**RE: Monte Vista Elementary School
3211 Monte Vista Dr. NE
Grading and Drainage Plan
Engineer's Stamp Date: 09/06/2022
Hydrology File: K16D017**

Based upon the information provided in your submittal received 9/12/2022, the Grading & Drainage Plan **is not** approved for Building Permit. The following comments need to be addressed for approval of the above referenced project:

Re: Monte Vista Elementary School, 3211 Monte Vista Dr. NE, Albuquerque, NM 87106
Grading and Drainage Plan, Hydrology File: K16D017
Comment Response/ Re-Submittal

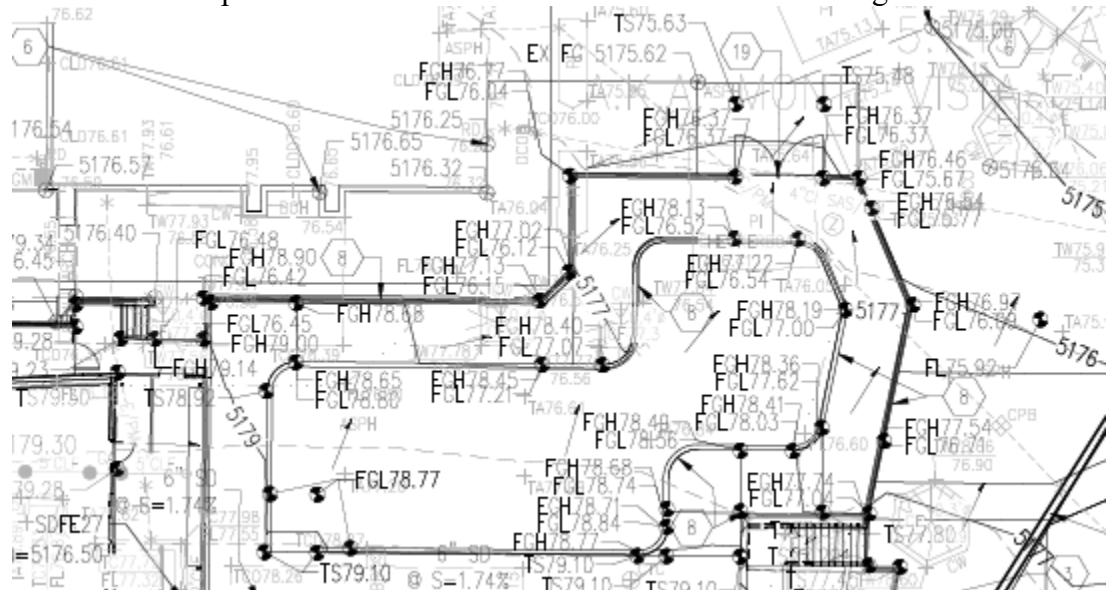
1. Please clean the plan up. It is really overwhelmed with information and is hard to read.
 - a. See below example screen shot. Cannot make sense of what is being constructed.

- c. Please follow example G & D sent previously to assist in readability of a G & D.
2. Construction limits are not defined. Place a boundary for construction limits on the set.
3. It is difficult to tell what works and what does not with what is presented. I do not want to review this in this format.

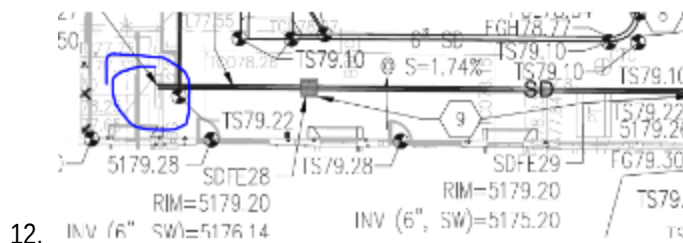
9. Please calculate the water quality volume required (this will include the entire construction area that is affected/changed for redevelopment per DPM CH 6).

Response: This is shown and explained in the DMP

C-201

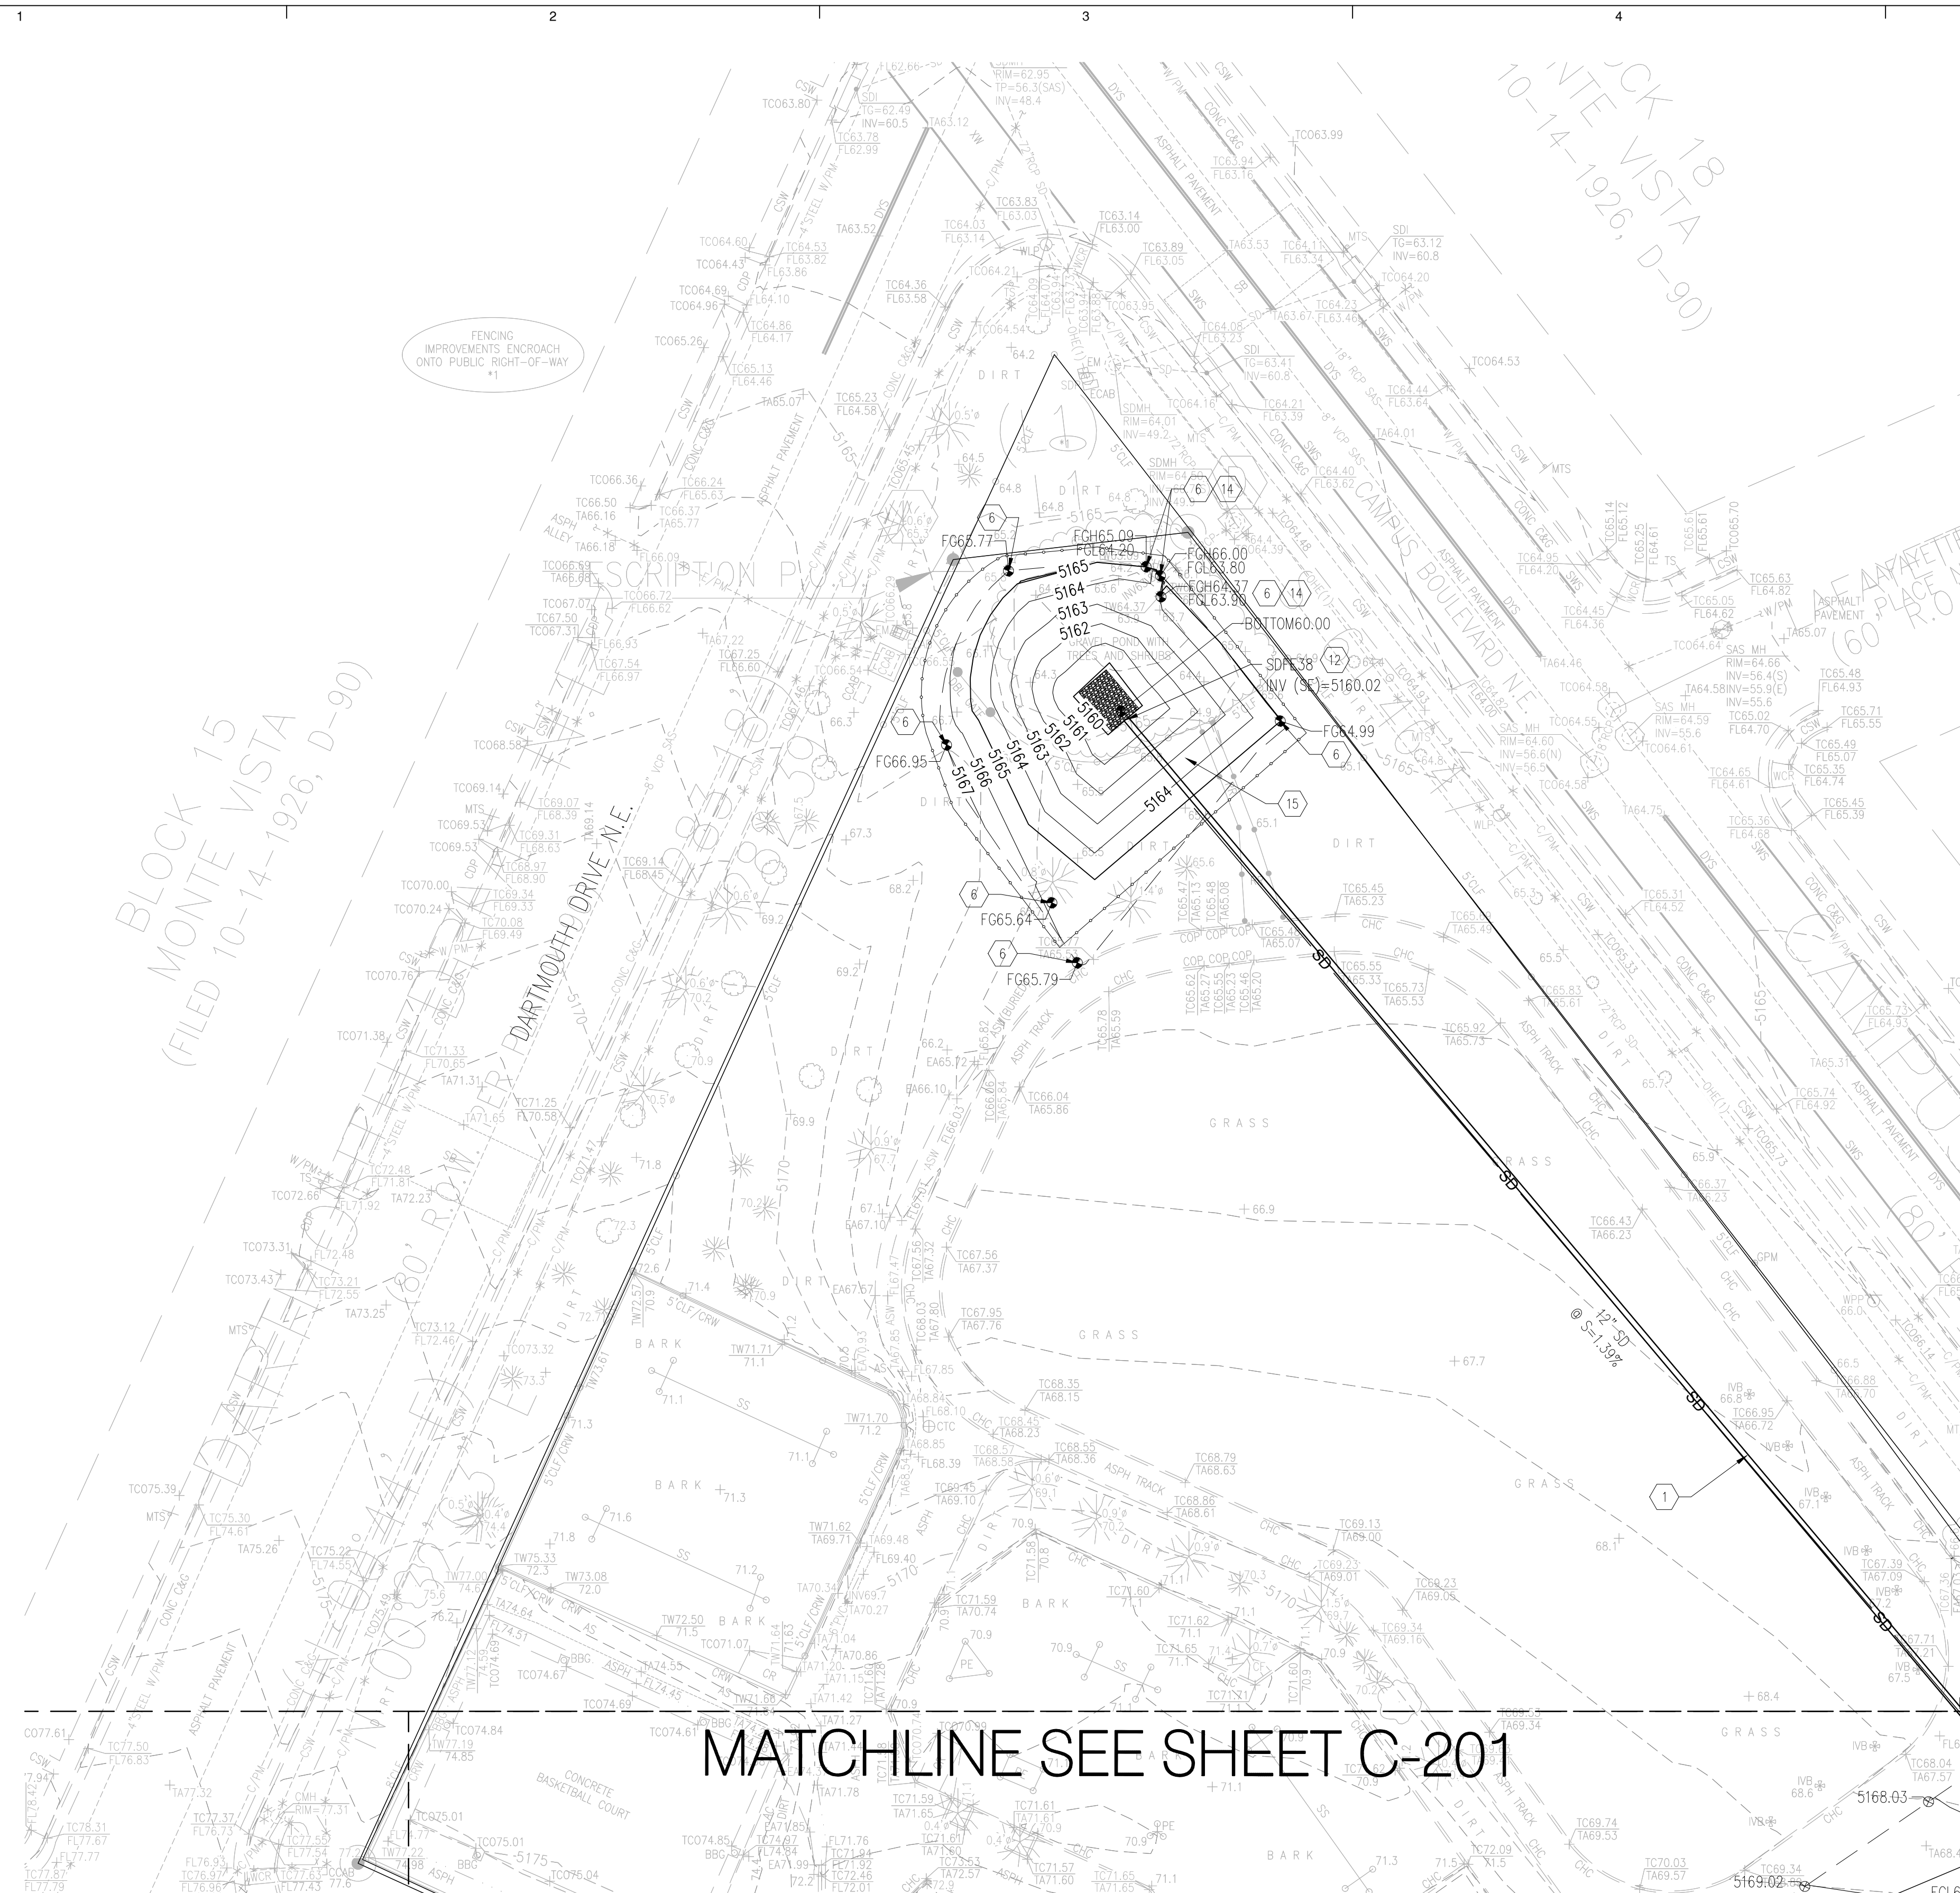
5. You are showing sections (A and B) on C-200 but do not show where these are on the site. Please show what location.

Response: This is shown on grading sheet C201.
